AGENDA – WORKSHOP OF THE PLANNING AND ZONING COMMISSION OF THE CITY OF PEARLAND, TEXAS, TO BE HELD OCTOBER 19, 2009 AT 7:00 P.M., IN THE COUNCIL CHAMBERS, CITY HALL, COMMUNITY CENTER, 3519 LIBERTY DRIVE, PEARLAND, TEXAS

1. **COUNCIL INPUT AND DISCUSSION:** REGARDING PEARLAND TOWN CENTER PLANNED UNIT DEVELOPMENT AMENDMENT FOR SIGNAGE. *Ms. Angela Gantuah, Senior Planner.*

AGENDA OF: October 19, 2009	ITEM NO.: Workshop No. 2
DATE SUBMITTED: October 7, 2009	DEPT. OF ORIGIN: Planning
PREPARED BY: Angela Gantuah	PRESENTOR: Angela Gantuah
REVIEWED BY : Mike Hodge	REVIEW DATE: Oct 9, 2009
SUBJECT: Request of Jackie Zeller with Curry Architecture, Agent for Harvest Development LLC. Owner, a Workshop regarding developing Pearland Retirement Residence.	
EXHIBITS: Application for workshop, and proposed Planned Development Document.	
EXPENDITURE REQUIRED: N/A	AMOUNT BUDGETED: N/A
AMOUNT AVAILABLE: N/A	PROJECT NO.: N/A
ACCOUNT NO.: N/A	
ADDITIONAL APPROPRIATION REQUIRED: N/A	
ACCOUNT NO.: N/A	
PROJECT NO.: N/A	
To be completed by Department:	
<input type="checkbox"/> Finance	<input type="checkbox"/> Legal
<input type="checkbox"/> Ordinance	<input type="checkbox"/> Resolution

Exhibit B: Interior Project Boundary

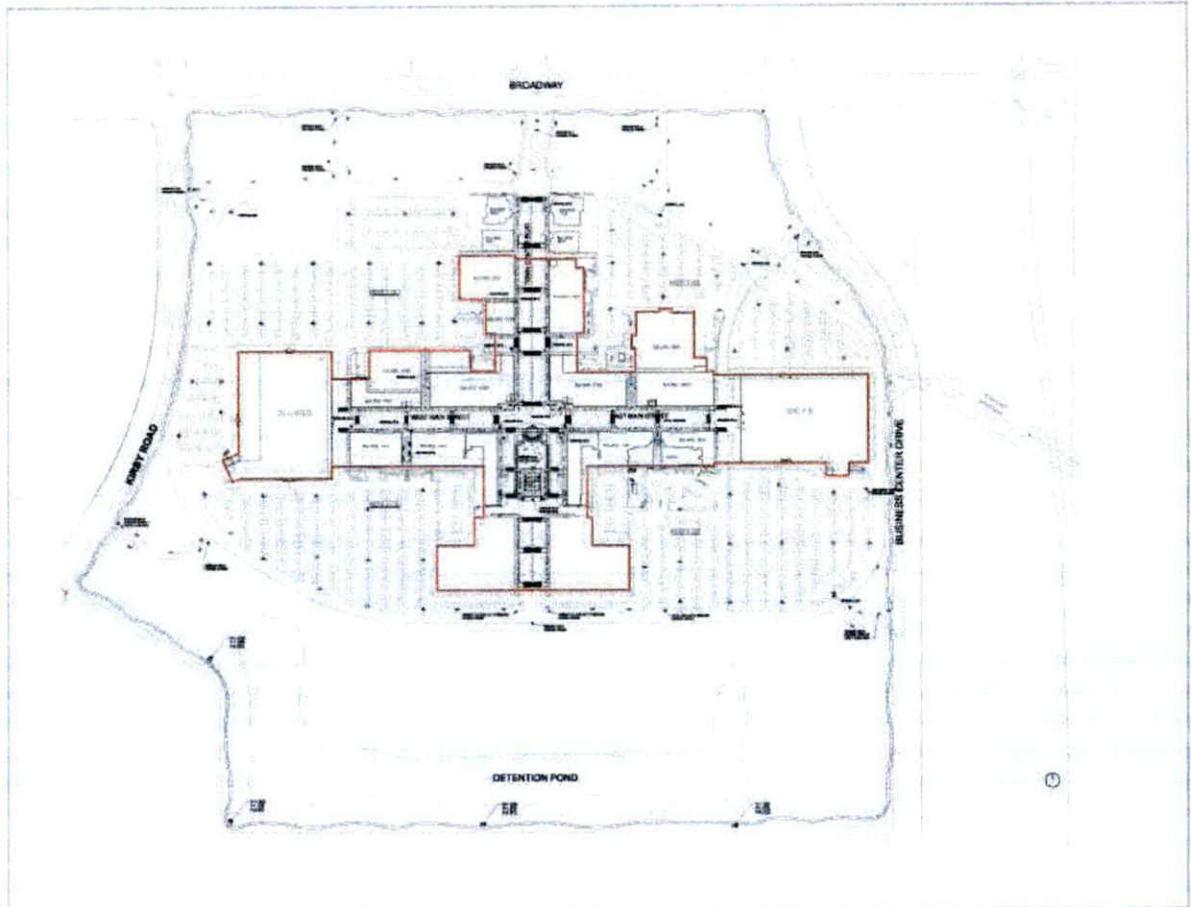
The applicant is requesting a workshop for the purposes of amending the Pearland Town Center PD to allow off-premise signs within the project boundaries as shown in Exhibit B, on page 39 of the PD Document.

Exhibit B-2: Off-premise Advertising Signs

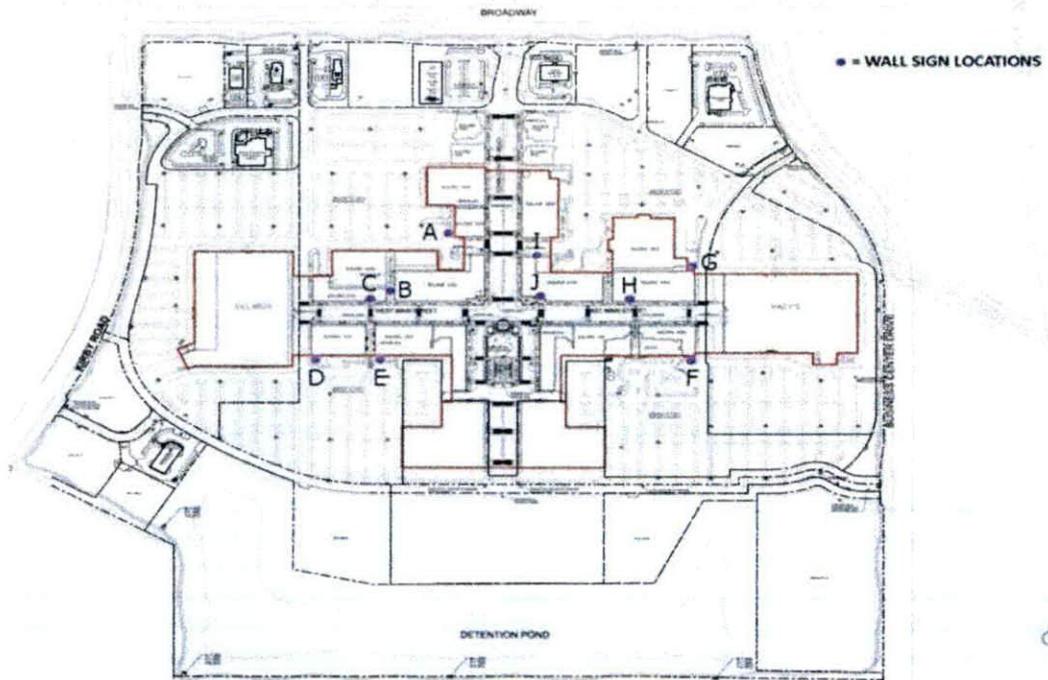
- 1) Reduce the number of signs.
- 2) Incorporate a Pearland Town Center background theme for these signs - as shown in the exhibit B-2
- 3) Reduce the area of advertising on these signs - provide specific areas.
- 4) Revise the PUD language to allow for off premise advertising signs- only on these signs.
- 5) Provide a diagram showing specific locations of these signs.
- 6) Provide criteria for these signs.
- 7) Show specific examples of the sign design and how it applies.
